Wisconsin Department of Transportation

Proposal #15: 2025-01-72
West Capitol Drive (STH 190)
12 Connecting Highway Intersections
Var Hwy
Milwaukee County

Letting of April 11, 2017

This is Addendum No. 01, which provides for the following:

Addendum No. 01
ID 2025-01-72
Revised Sheet 23
March 30, 2017

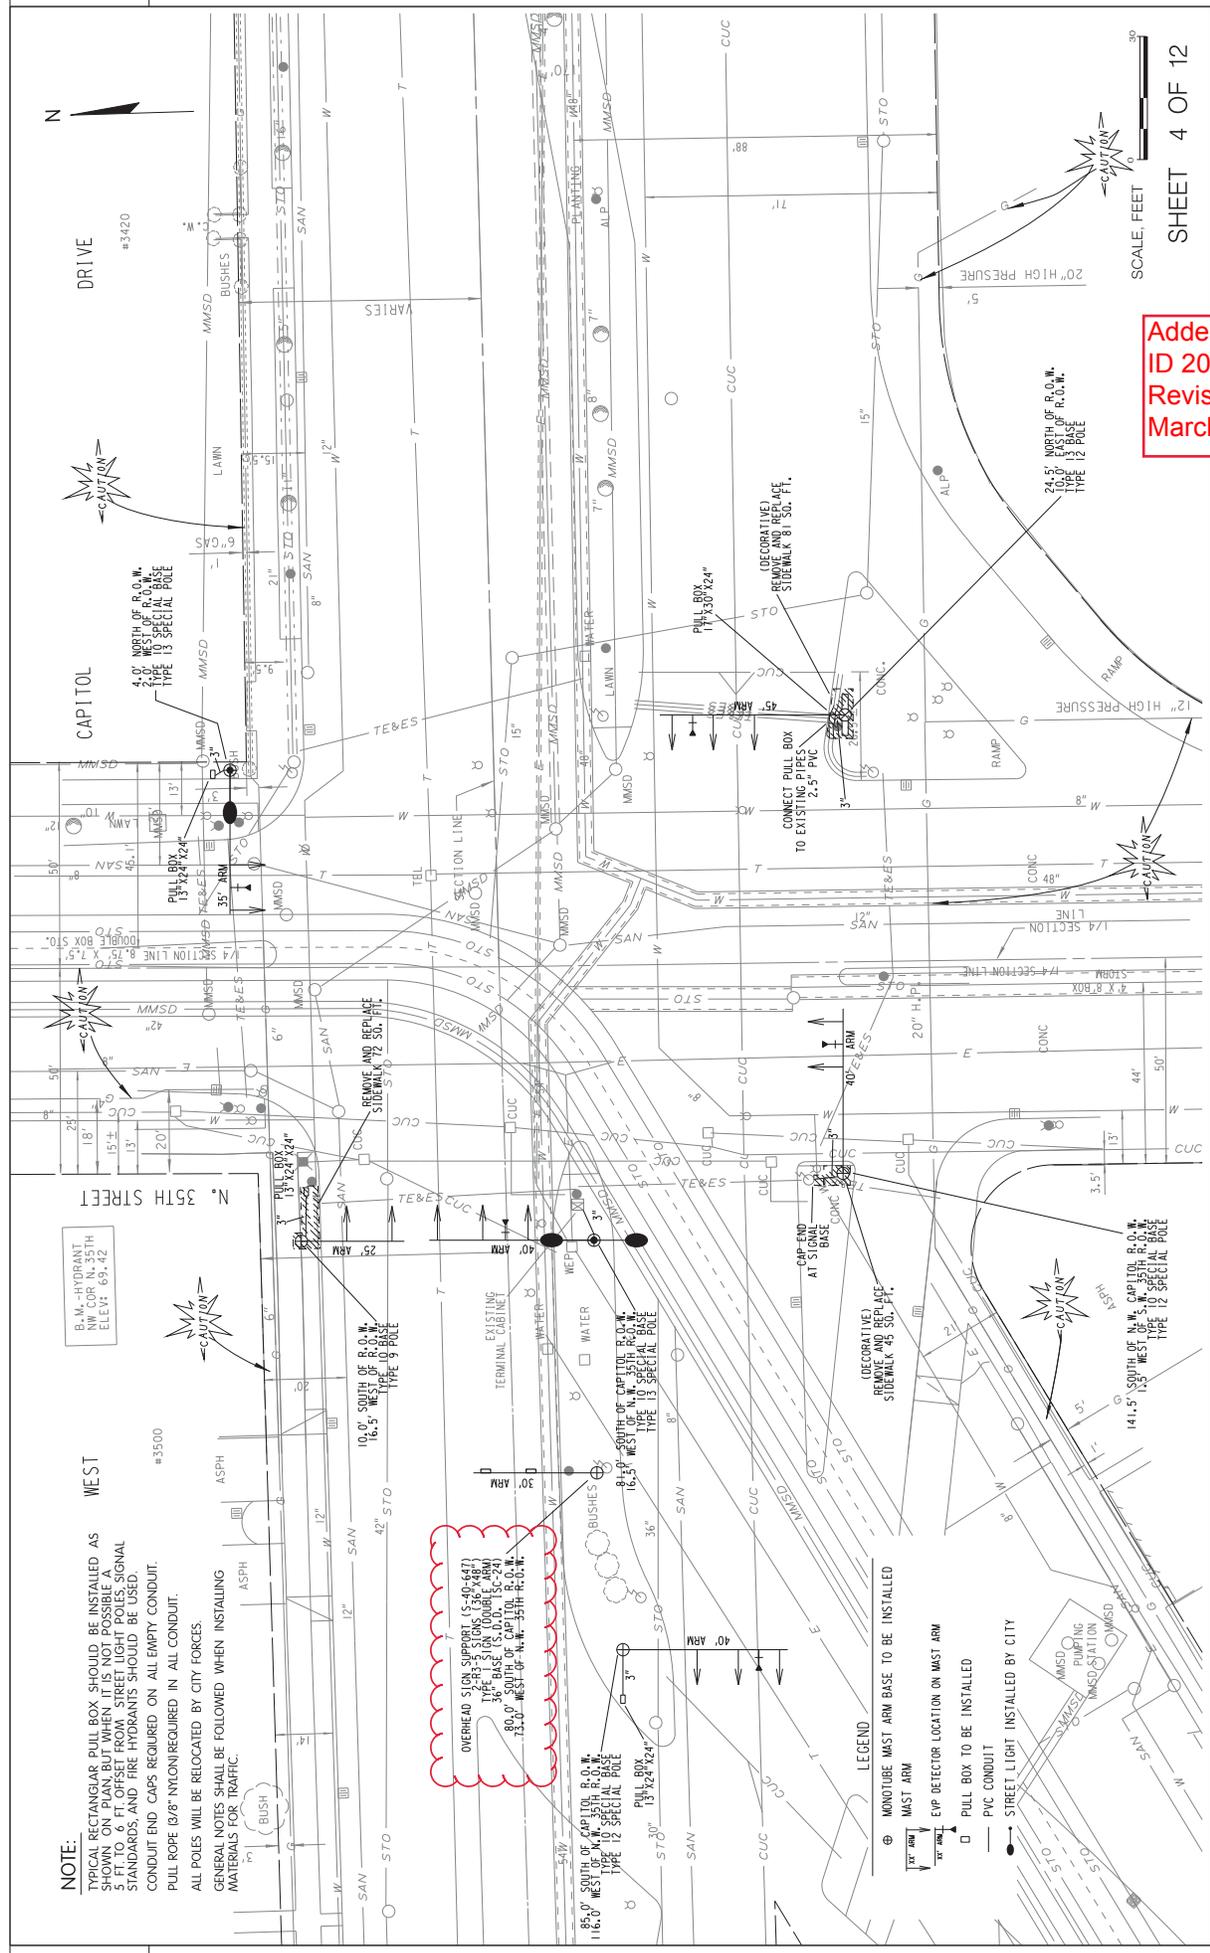
Revised Plan Sheets	
Plan Sheet	Plan Sheet Title (brief description of changes to sheet)
23	Sign Details: Added sign numbers and additional description. Added note for contractor to furnish and install I.D. plaques as per S.D.D. Plaques are incidental to the associated bid items
27	Added structure number for overhead sign support
29	Added structure number for overhead sign support
34	Added structure number for overhead sign support

CONTRACTOR SHALL:
SUBMIT SHOP DRAWINGS OF OVERHEAD SIGN SUPPORT, FOOTING IS INCIDENTAL TO OVERHEAD SIGN SUPPORT.
PROVIDE DESIGN CALCULATION.
SHOW SIGNS ON SHOP DRAWINGS.
SIX ANCHOR BOLTS SHALL BE USED PER S.D.D. S-15C22-02 AND S-15C24-02
FURNISH AND INSTALL IDENTIFICATION PLAQUES AS PER S.D.D. "STRUCTURE IDENTIFICATION PLAQUES, PUMP GATES, SIGN BRIDGES, OVERHEAD SIGN SUPPORTS & TRAFFIC SIGNALS" PLAQUES ARE INCIDENTAL TO THE OVERHEAD SIGN SUPPORT ITEMS.

Addendum No. 01
ID 2585-00-70
Revised Sheet 107
March 30, 2017

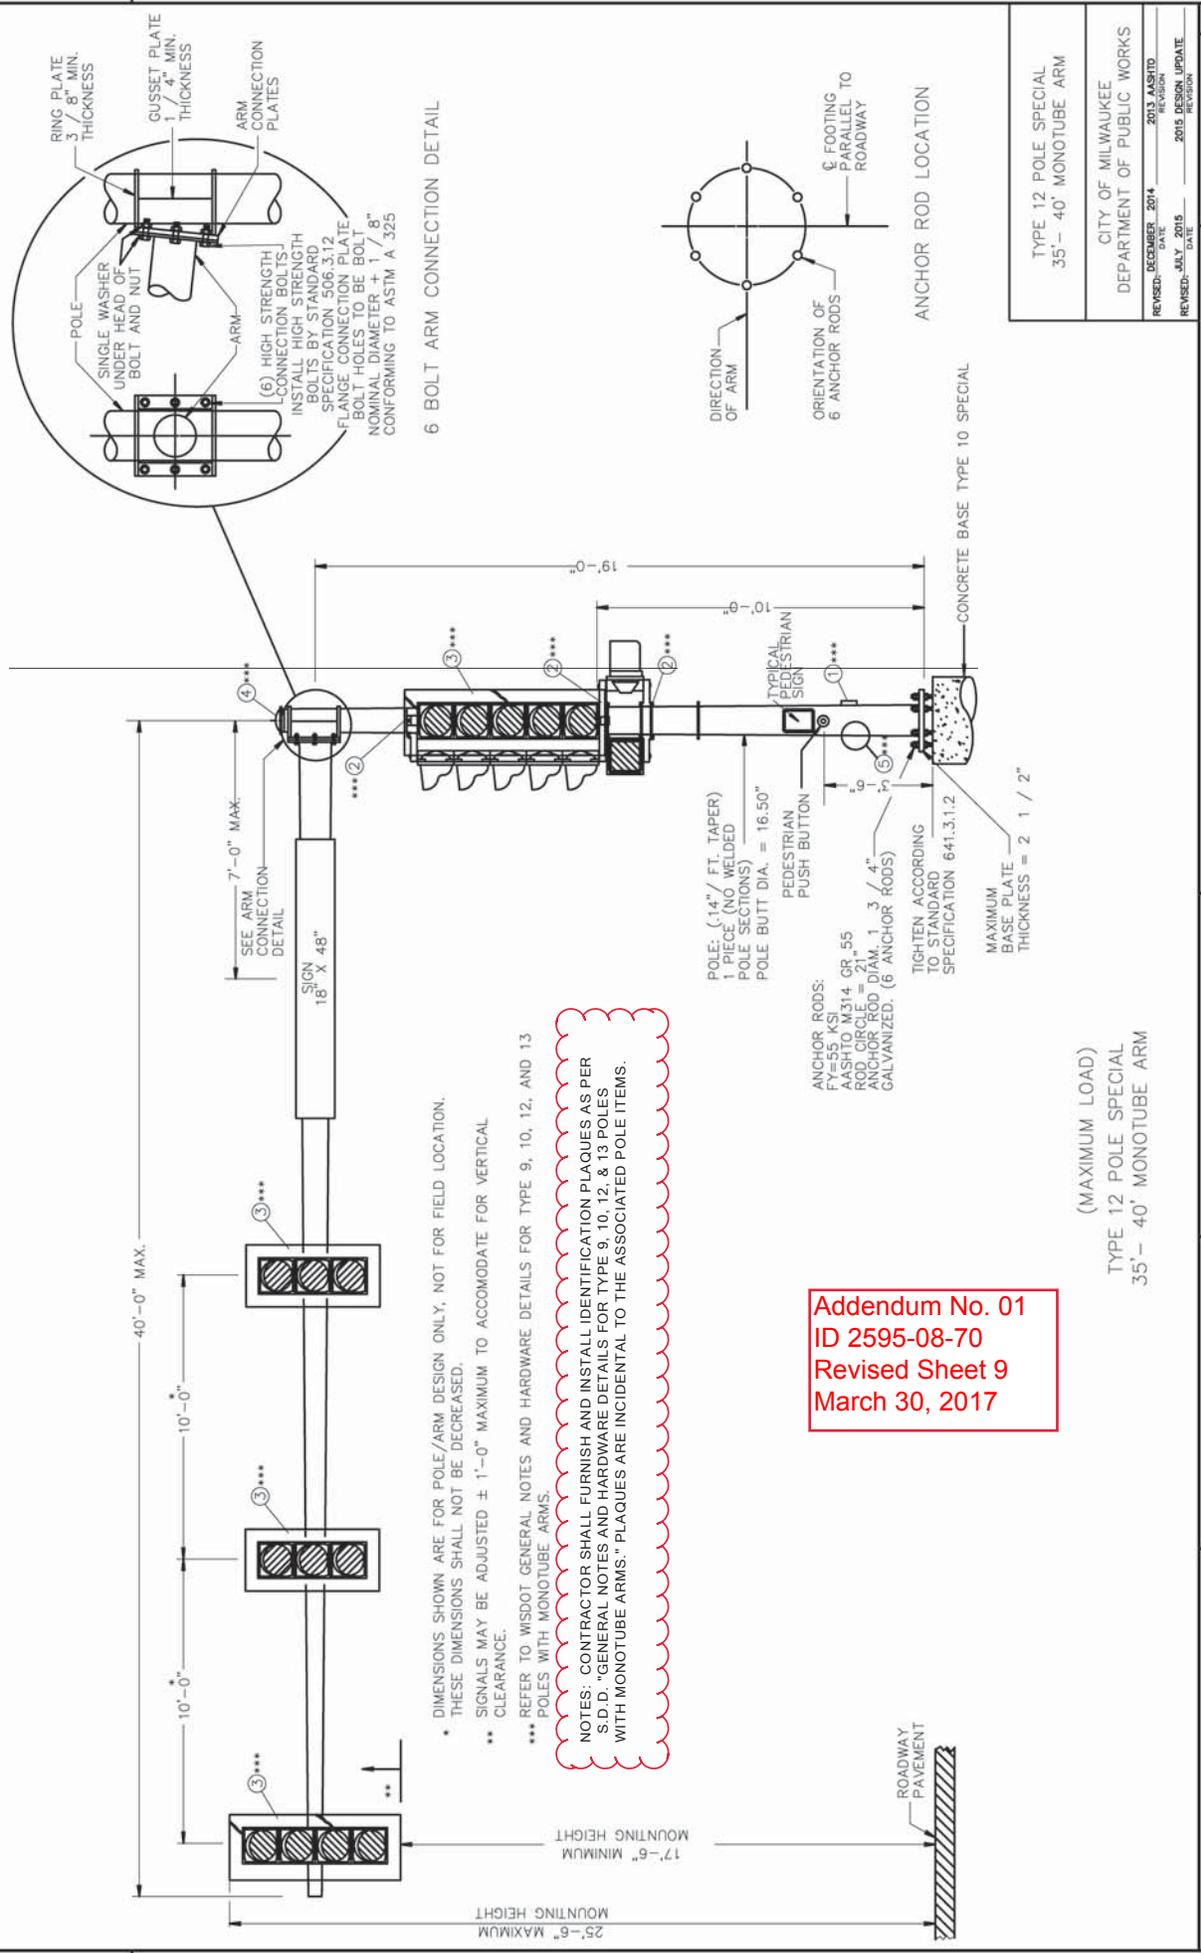
Revised Plan Sheets	
Plan Sheet	Plan Sheet Title (brief description of changes to sheet)
107	Added note for contractor to furnish and install I.D. plaques as per S.D.D. Plaques are incidental to the associated bid items

NOTES: CONTRACTOR SHALL FURNISH AND INSTALL IDENTIFICATION PLAQUES AS PER S.D.D. *GENERAL NOTES AND HARDWARE DETAILS FOR TYPE 9, 10, 12 & 13 POLES WITH MONOTUBE ARMS* PLAQUES ARE INCIDENTAL TO THE ASSOCIATED POLE ITEMS.

Addendum No. 01
 ID 2595-08-70
 Revised Sheet 9
 March 30, 2017

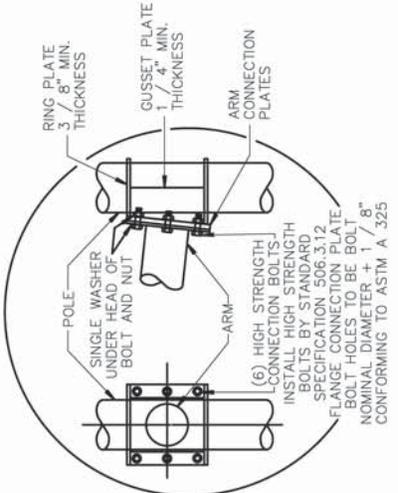
Revised Plan Sheets	
Plan Sheet	Plan Sheet Title (brief description of changes to sheet)
9	Added note for contractor to furnish and install I.D. plaques as per S.D.D. Plaques are incidental to the associated bid items
10	Added note for contractor to furnish and install I.D. plaques as per S.D.D. Plaques are incidental to the associated bid items

NOTES: CONTRACTOR SHALL FURNISH AND INSTALL IDENTIFICATION PLAQUES AS PER S.D.D. "GENERAL NOTES AND HARDWARE DETAILS FOR TYPE 9, 10, 12, & 13 POLES WITH MONOTUBE ARMS." PLAQUES ARE INCIDENTAL TO THE ASSOCIATED POLE ITEMS.
